ADDENDUM No. 5
Replacement of Upper Concourse Ad Panels
Oriole Park at Camden Yards
MSA Project No. 19-071

Date Issued: June 14, 2019

DRAWN BY: JEP	PROJECT NO.
CHECKED BY: KMM	1304.18.00
SCALE: AS SHOWN	DRAWING NO.
DATE: 8-13-13	SK-1

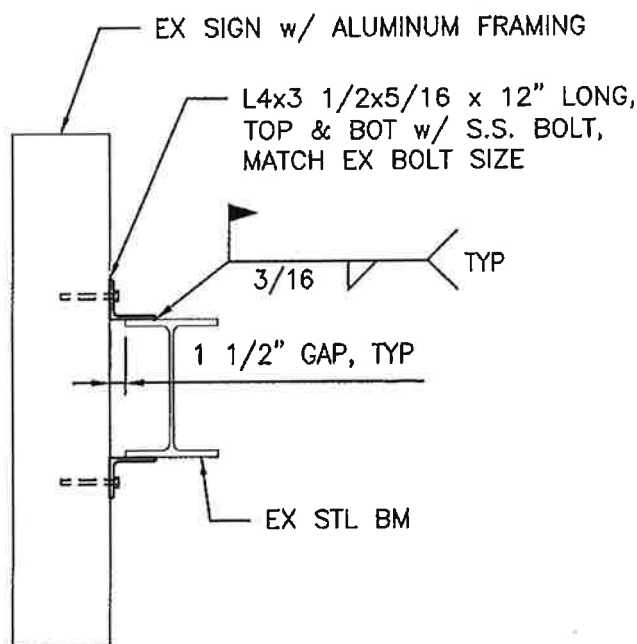
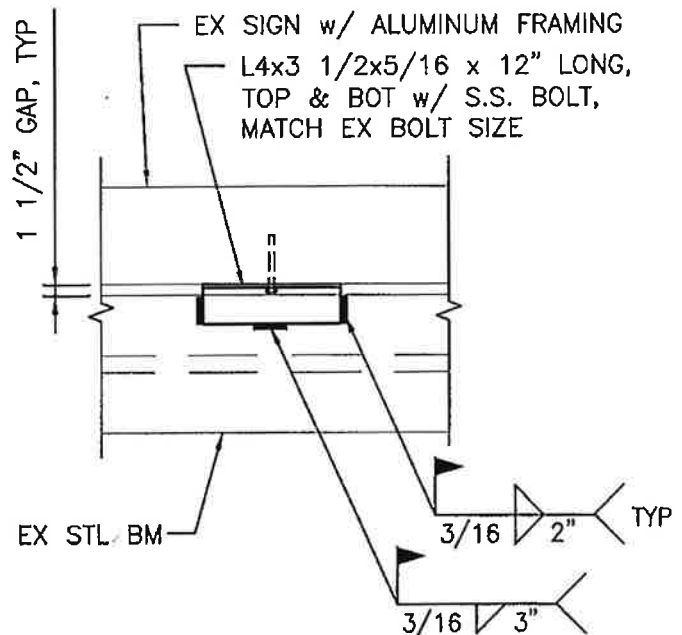
Understood. If artwork couldn't be reused we would work with the Orioles to replace.
8. Intentionally Omitted
9. Please provide SK-1 Drawing.

Please see the 3 pages attached.
10. What is the maximum weight or lift size allowed in area below club level signs?
